EPA-AA-TEB-511-83-12

EPA Evaluation of the HYDRO-VAC Device Under
Section 511 of the Motor Vehicle Information
and Cost Savings Act

August 1983

Test and Evaluation Branch
Emission Control Technology Division
Office of Mobile Sources
U.S. Environmental Protection Agency

**HYDRO VAC SYSTEM
INSTALLATION SCHEMATIC**

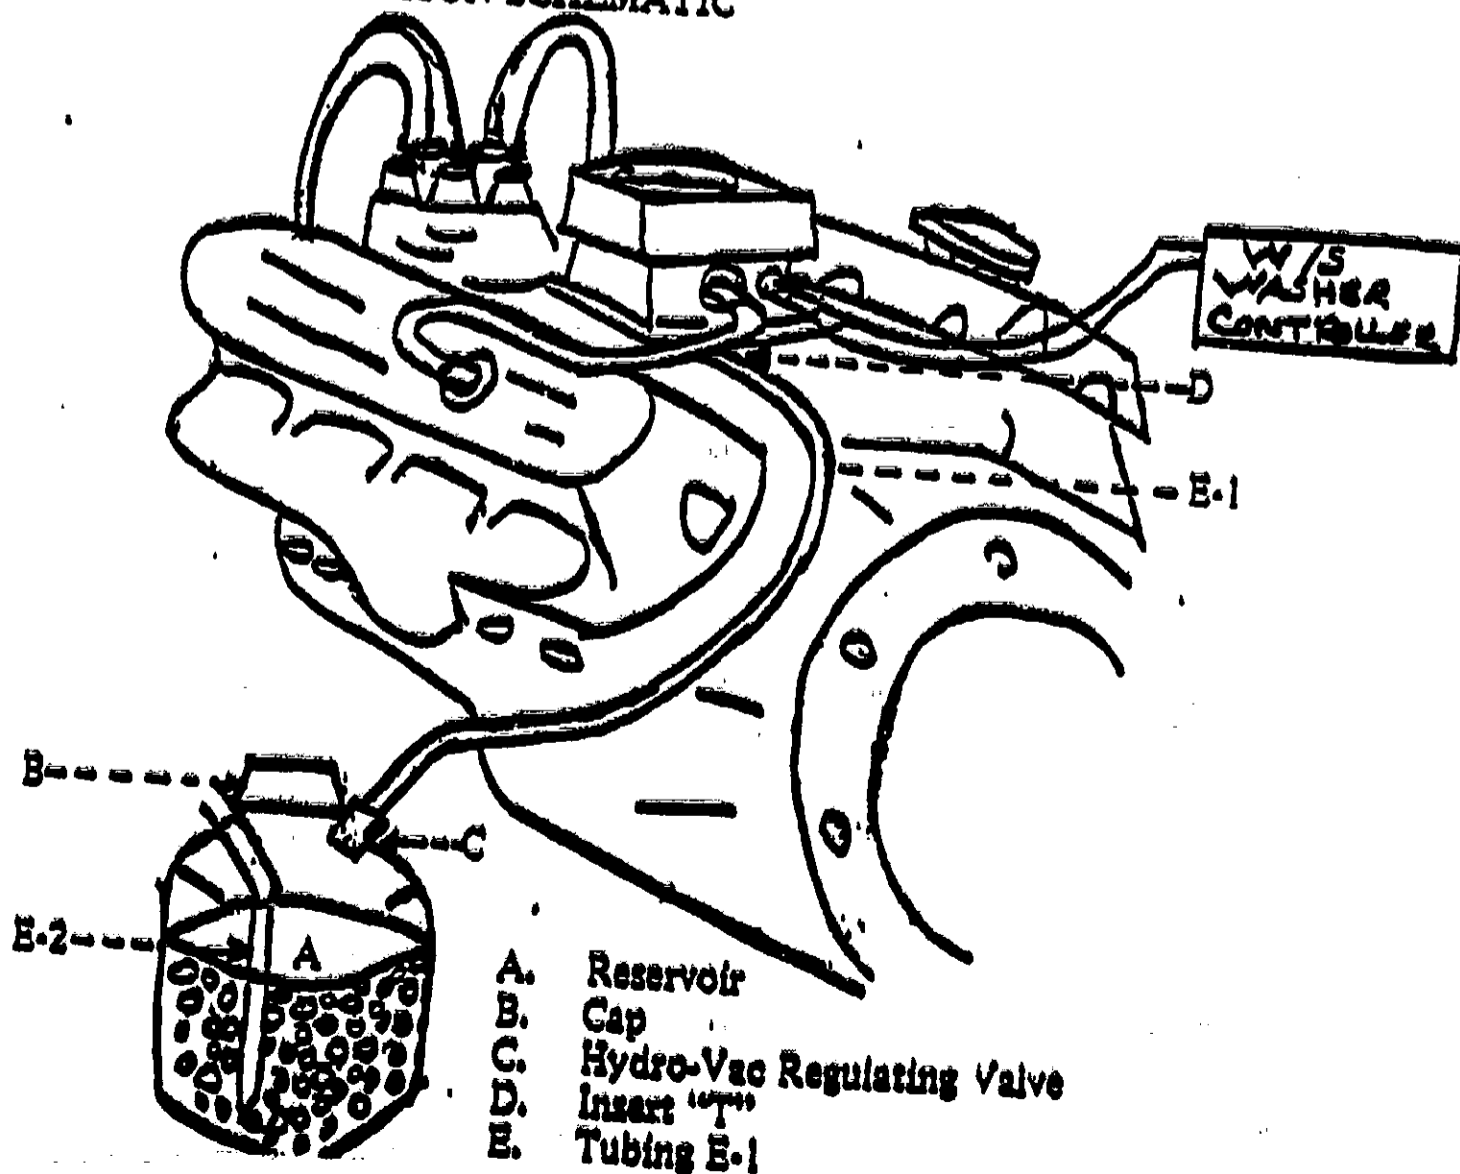
- d. The installation instructions (Attachment B) were not clear as to whether manifold and/or ported vacuum signals should be used to operate the device. Another concern is that the distributor vacuum advance line is suggested as being an acceptable point to tap into for the operating vacuum signal. Because the device does bleed air, it can only weaken the signal sensed by the distributor vacuum advance unit, and consequently the timing will not advance properly. Because vacuum advance can have a significant impact on fuel economy during cruise operation, the device may have an adverse effect on fuel economy benefits for some engines.

Another concern is that a purchaser who locates a vacuum source when the engine is cold, installs the device, and observes bubbles and turbulence in the fluid reservoir (checkout procedure recommended by instructions), may find the device does not function when the engine is at operating temperature. The reason for this is that inline temperature sensors are used extensively on today's engines for purposes of modifying the signal. Thus, it is important the selection of the vacuum line be done when the engine is at operating temperature.

2. You indicate that a source of manifold vacuum is required yet you suggest using the line to the distributor advance mechanism. In most cases, this line supplies ported vacuum. I suggest you revise your instructions to accommodate this inconsistency and provide information on how an air bleed in this line will not upset the calibration of the advance curve.

5. Item 4 of your installation instructions states that after device installation the engine is started and "bubbles and turbulence should be forming in the reservoir," thus indicating the device is functioning properly. Considering that many vehicles incorporate a temperature valve to control the ported vacuum signal to the distributor, it may be that there will be no vacuum to your device while the engine is cold. Of course, this depends on which vacuum line is used for the device. Have you considered this potential problem?

The applicant was asked about these concerns (Attachment C). He responded (Attachment D) that the device would work on either ported or manifold vacuum, but would give better results on the latter. He also stated that on the vehicles he tested, he did not have to reset the timing because of the device being attached to the distributor vacuum line. EPA is still of the opinion that tapping into the distributor vacuum line can only have an adverse effect on timing and fuel economy. The applicant did not address the temperature sensor issue. Attached to the applicant's letter are revised installation instructions with improved statements regarding the selection of vacuum lines. The revised instructions could be further improved by stating that vacuum line selection should be made with the engine at operating temperature.

2. In some applications this distributor advance line is a ported vacuum, not manifold. However, on the gasoline powered cars where I installed the Hydro-Vac unit, this vacuum source was manifold vacuum. In no case has it been necessary to re-set the timing because of the Hydro-Vac vacuum line being connected to this distributor advance vacuum line. The Hydro-Vac uses only a small portion of the available vacuum on this line. I am glad you brought this to my attention as I will change the Literature to reflect this.

6. The Hydro-Vac unit will work on either manifold vacuum or ported vacuum, however it will give better results when hooked up to manifold vacuum. I will revise my literature to incorporate change in instructions in locating proper vacuum line.
